Determination 2020/014

Regarding the authority's refusal to grant an amendment to a building consent for a revised timber remediation methodology and window joinery flashing system at 42 Stanmore Bay Road, Auckland

Figure 1: Jamb detail showing the flashing system (not to scale)

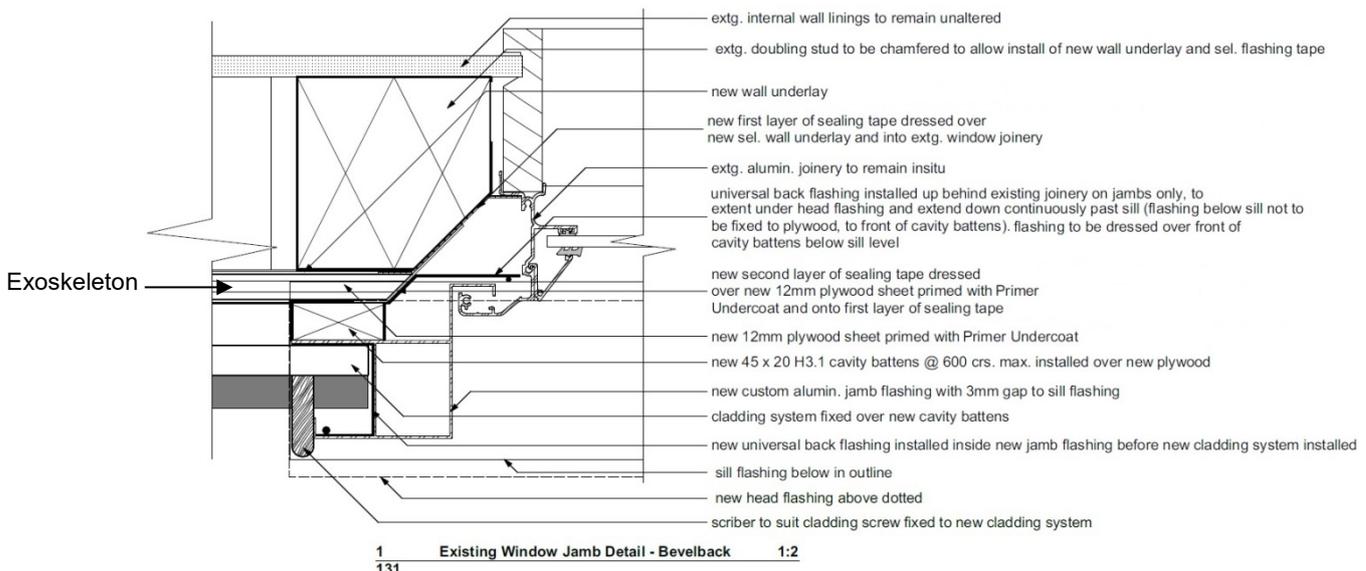
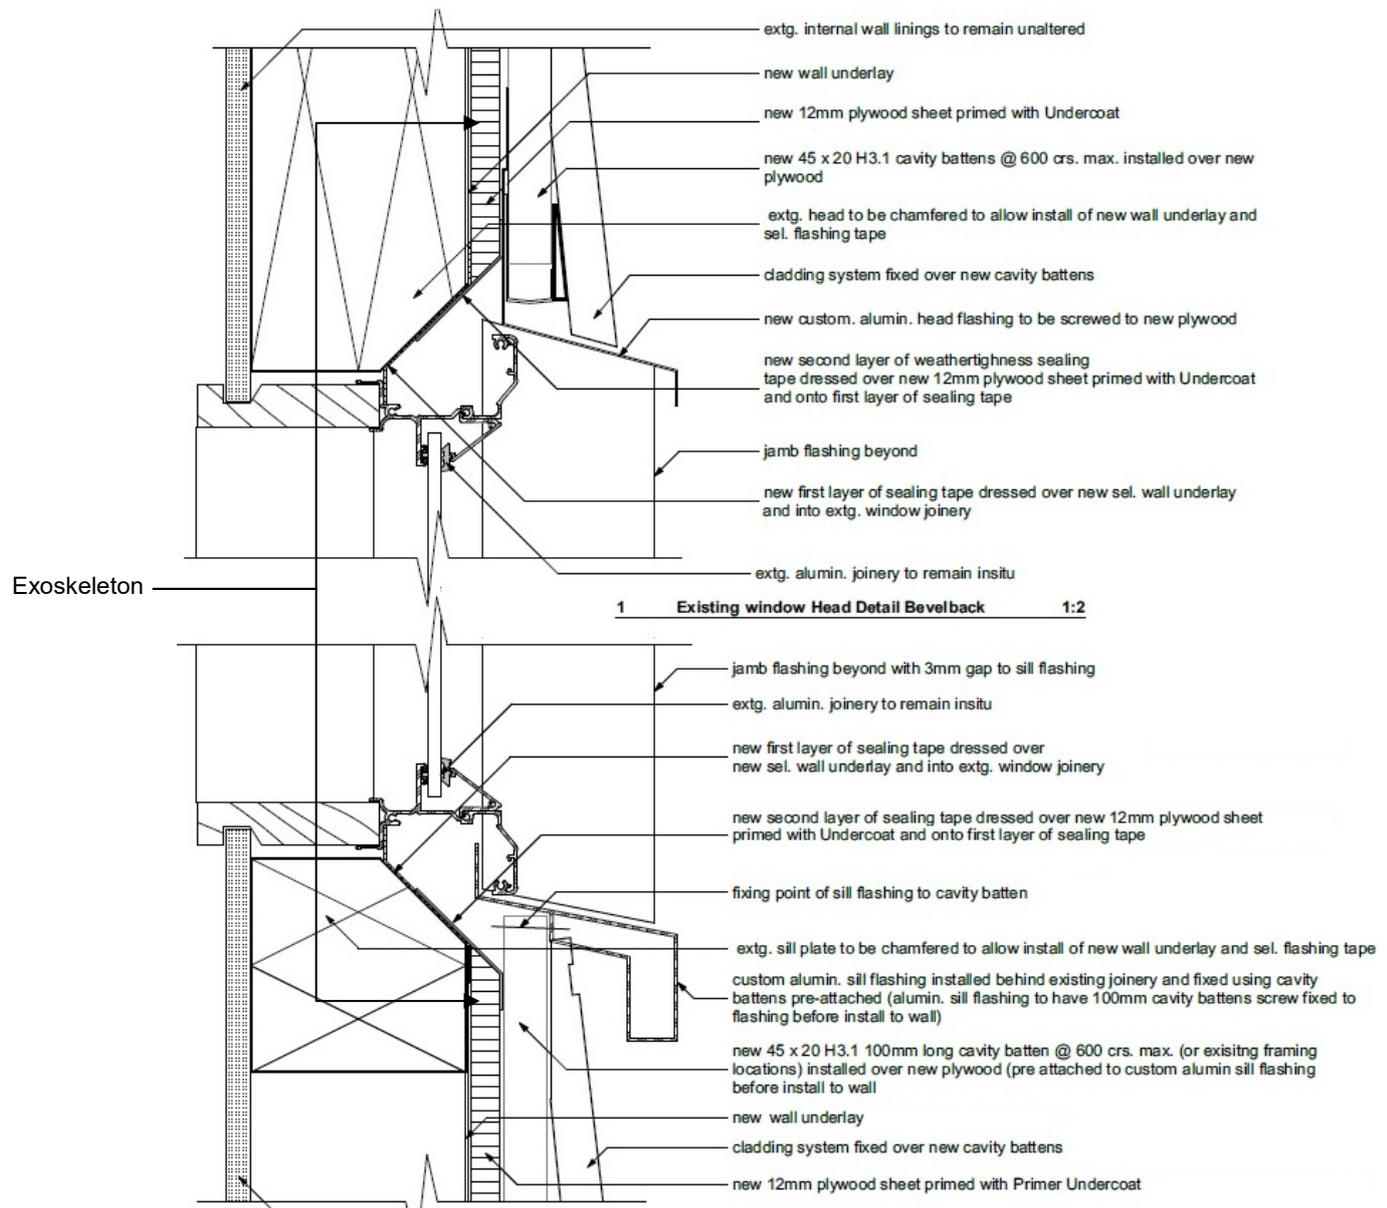
d) Technical literature for [the proprietary tape product] confirms that the adhesion of the tape to the window joinery is excluded from the product appraisal. Provide independent documentation which demonstrates this method will perform for the required 15 year durability period.

g) Product literature and product appraisal indicate [the proprietary tape product] is only for use around head and jams.

h) Product appraisal states that [the proprietary tape product] is to be used in conjunction with flashings and air seals, not as a replacement for these features.

Please demonstrate how the proposed window flashing system achieves compliance with the NZBC specifically clauses E2, B1, B2. Please address how the installation of this system into the existing structure ensures compliance with B1, B2 is maintained

- The draft E2/VM1 report provided was generic and not site specific. The report lacked detail on how compliance would be achieved if the windows were left in place.
- Despite assurances from the agent that the test had been successful, the draft weathertightness test report advised the system required further work (refer paragraph 2.4.5) and the testing was incomplete.

- The E2/VM1 test results provided were in draft form, incomplete, and the authority raised concerns regarding the testing procedure. The draft conclusion stated the flashing system needed further work to ensure it was consistently weathertight. It is also not clear whether the samples reflect what is actually proposed for the subject building (refer paragraph 2.4.2).
